Date: September 10, 2018
CSB No.: 2018-04
Title: QUIKLOOK 3-FS Encoder Not Supported
Affected Products: QUIKLOOK 3-FS Model 160600E
QUIKLOOK FS Version 2016.365 or Older
Severity: Critical

Issue Description:

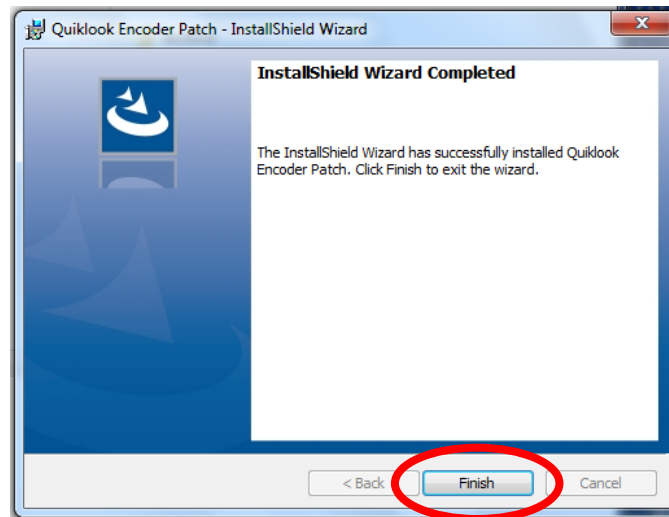
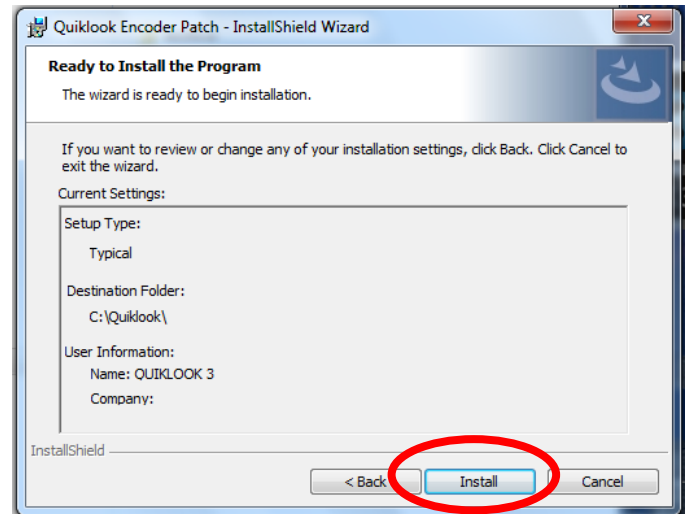
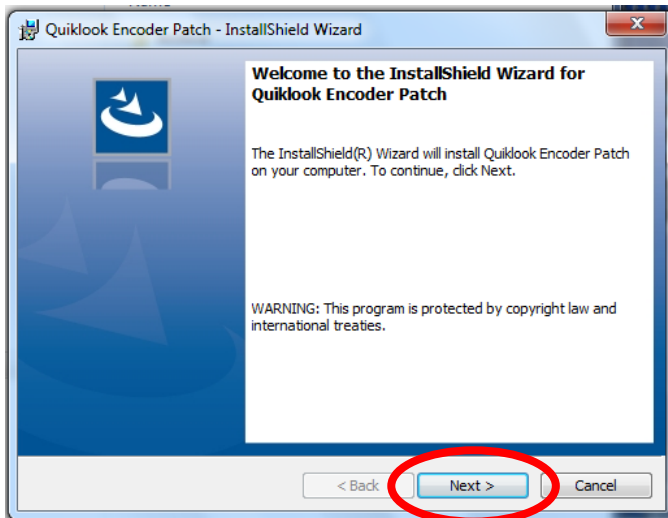
1. Load the patch installer onto a thumb drive that has been sanitized.

2. Turn on the QL3FS acquisition system. Close the QUIKLOOK FS program after it starts automatically.
3. In Windows Explorer, navigate to the thumb drive and locate the installer “QUIKLOOK Encoder Patch”. Double click to start the installation process. Shut down the QL3FS when the installation is complete.

Procedure to verify the patch (Optional)

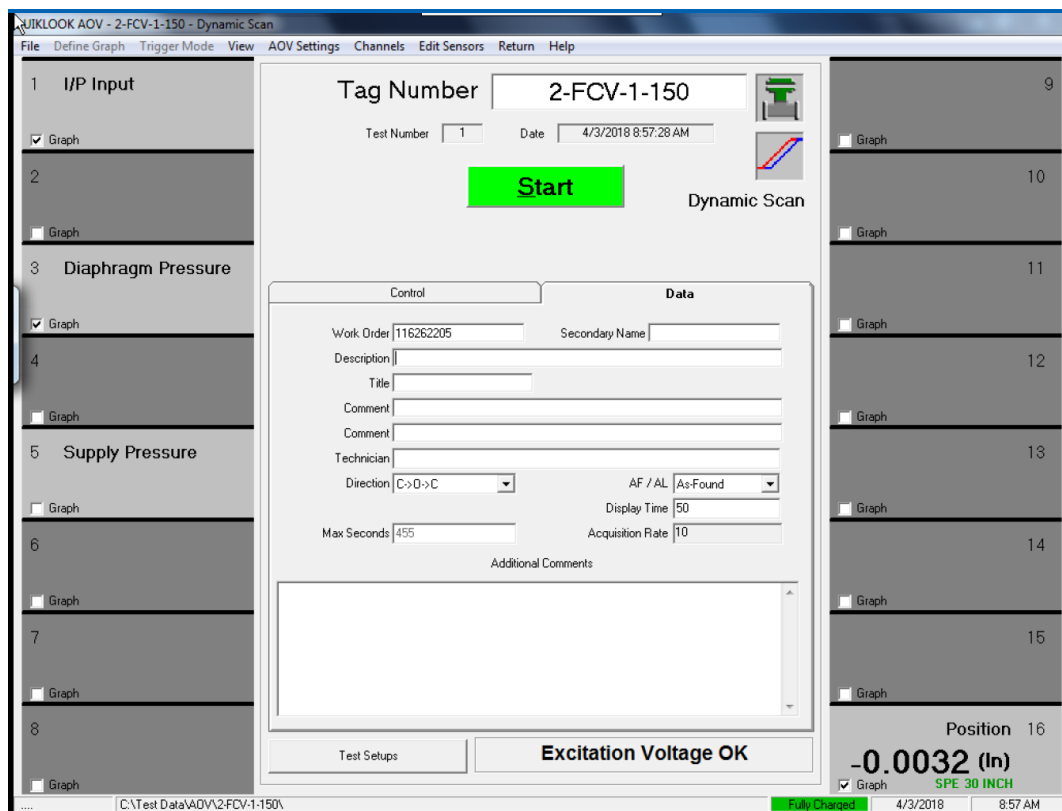
4. Turn on the QL3FS acquisition system. Close the QUIKLOOK FS program after it starts automatically. Do not go to the acquisition screen on initial launch.
5. Connect digital encoder sensor (linear or rotary) into channel 15 or 16.
6. In Windows Explorer, find a test file or tag file that is stored outside of the C:\QUIKLOOK directory (example: C:\Test Data\MOV).
7. Double click the test file or tag file to automatically launch QUIKLOOK FS.
8. Navigate to the Acquisition screen and confirm the sensor is recognized successfully. Move the digital sensor to verify the channels are functioning correctly. Note that channel 15 or 16 will need to be set to "Active" in order to acquire data.
